Technical Service Bulletin

PRODUCT(S) **3620 Sweeper**
AFFECTED:

SUBJECT: Side Brush Adjustment – During machine installation, the side brush support bracket must be adjusted down from the shipping position.

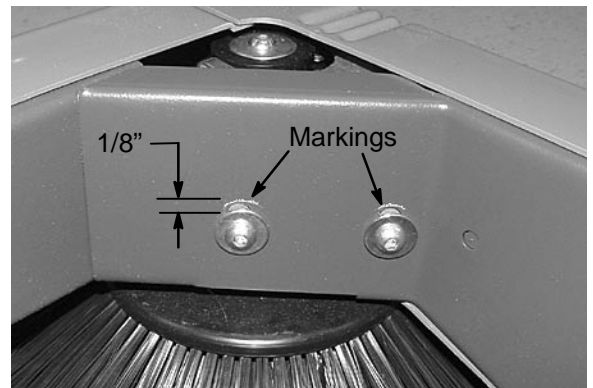
PURPOSE: To achieve optimum performance and to prevent potential damage to side cover. Follow the Side Brush Adjustment instructions as described below.

1. Switch the side brush lift lever to the OFF position and remove the key.
2. Tilt machine back and remove the screw and washer from the side brush drive shaft.
3. Position the brush on the shaft and replace the washer and screw using a 10mm wrench.
7. Loosen both screws using a 5mm Allen Wrench.
8. Lower the Side Brush down a minimum of 1/8". Use the reference marks to measure the movement.

4. Remove the front Hopper.
5. Locate the two adjustment screws on the inside right front corner.
6. Using a scribing tool, etch a small mark around the top edge of both flat washers. These marks will be used as reference points.
9. Re-check adjustment and tighten both screws.
10. Replace Hopper and test the side brush for proper operation.
